Office Action Summary

10/005,000

LEE ET AL.

DETAILED ACTION

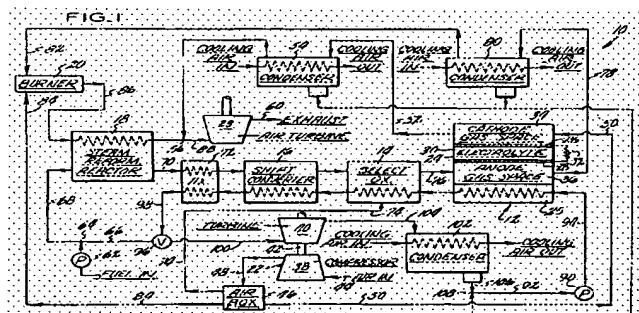
Bloomfield discloses a fuel cell power plant (TITLE) comprising as shown in **Figure 1** below a pump 90 delivering water via a conduit 92 into thermal exchange relationship with stack 12 via a conduit 94 by passing the water through the thermal exchange portion 25 of the stack (COL 5, lines 28-32). It is disclosed the fuel cells comprises a single cell 24 and a thermal management portion 25 (COL 3, lines 23-27). Bloomfield discloses that the liquid is increased in pressure by pumps (COL 4, lines 1-5). Bloomfield further discloses that part of the water is changed to steam as it passes through the stack 12. The water and steam is superheated by passing it into heat exchange relationship with the fuel conditioning apparatus. It is further heated in the selective oxidizer 14 and the shift converter 16 and in the heat exchanger 72 (COL

5, lines 32-40). The steam then leaves the heat exchanger 72 and is delivered to a valve 96. Then, the remainder of the superheated stream is delivered into turbine 40 (the expander) via a conduit 100. The turbine drives the compressor 38 for compressing the air for the stack. The turbine is a steam driven turbine, however, any steam driven engine operably connected to run a compressor may be used (COL 5, lines 40-50).

Bloomfield further teaches that the exhaust from the turbine 40 is delivered into a condenser 102 via a conduit 104. Heat is removed from the steam by passing air through the condenser as shown. Liquid water, or possibly a mixture of liquid water and steams, leaves the condenser 102 via a conduit 106 and is combined at 108 with water recovered from the anode and cathode effluent gas streams in the condensers 54, 80. The water is then delivered to the pump 90 via the conduit 92 and the process starts again (COL 5, lines 50-62). It is disclosed that the amount of water lost in the Rankine cycle loop is recovered in the condensers 54, 80 and which is combined at 108 with the water which recirculates through the loop (COL 6, lines 1-6).

Hence, Bloomfield teaches the specific pump, heat generating fuel cell system, expander, the compressor (the second fuel cell system component) and the condenser satisfying the specific spatial relationship and functional configuration as instantly claimed.
